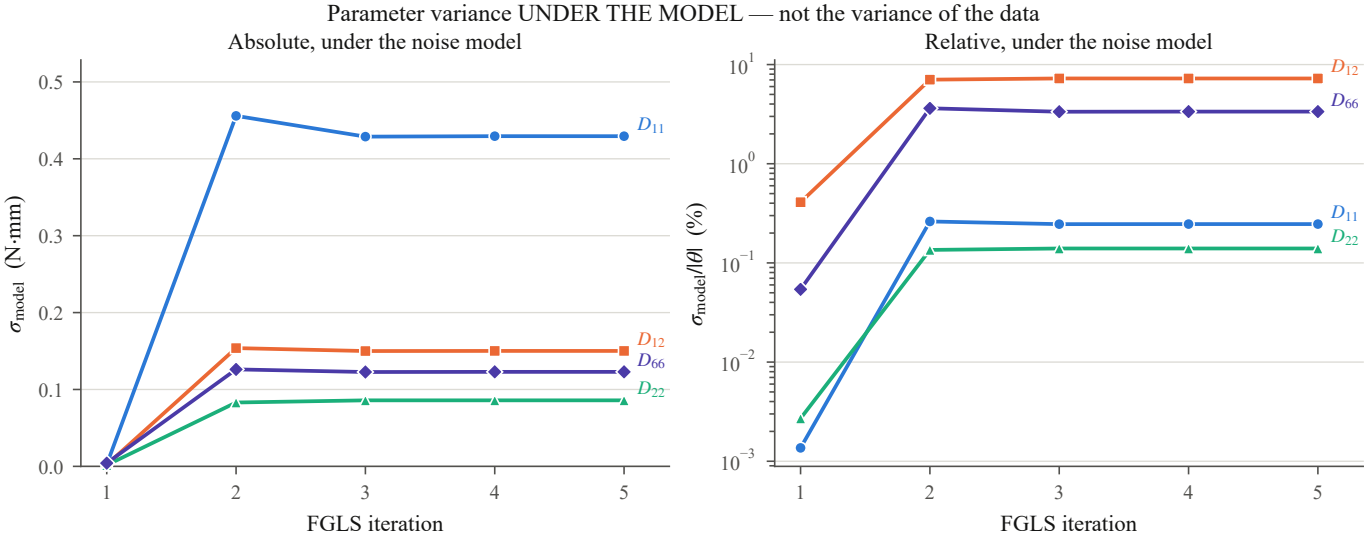
These curves are eq. (20) evaluated on eq. (3) exactly as derived ($\kappa = 1$; the measured spatial correlation is reported in fig. D but never folded in).

They answer: "if the ONLY error were spatially white DIC noise with covariance $\hat{\Gamma}$, how much would $\hat{\theta}$ move?" They do NOT answer "how well is D_{ij} known?".

The data reject that noise model at $\chi^2/\text{dof} = 830$: it accounts for 0.12 % of the observed residual variance. An interval to quote is at least $\sqrt{\chi^2/\text{dof}} = 29\times$ these values, and even that assumes the misfit is a pure scale error rather than a shape error.
